PRODUCT CHANGE NOTIFICATION

Bourns® Model CDSOT23 Series TVS Diodes

Additional Assembly and Test Manufacturing Location

Typical Part Marking

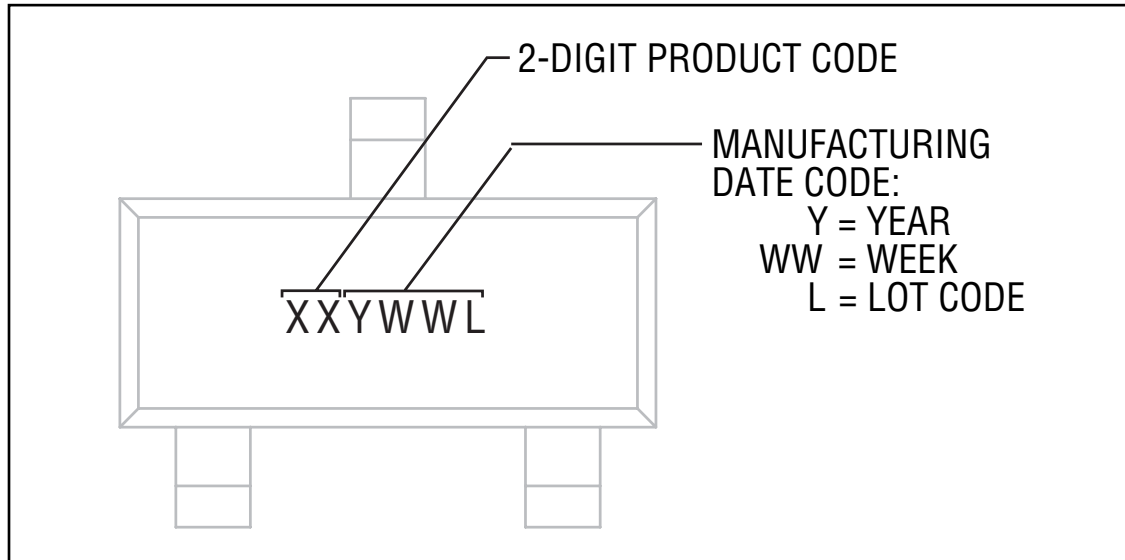
The part marking will be used to identify units produced at the new assembly and test manufacturing site. The lot code (L) of the new site will follow alphabetic characters while the current site will continue to use numbers.
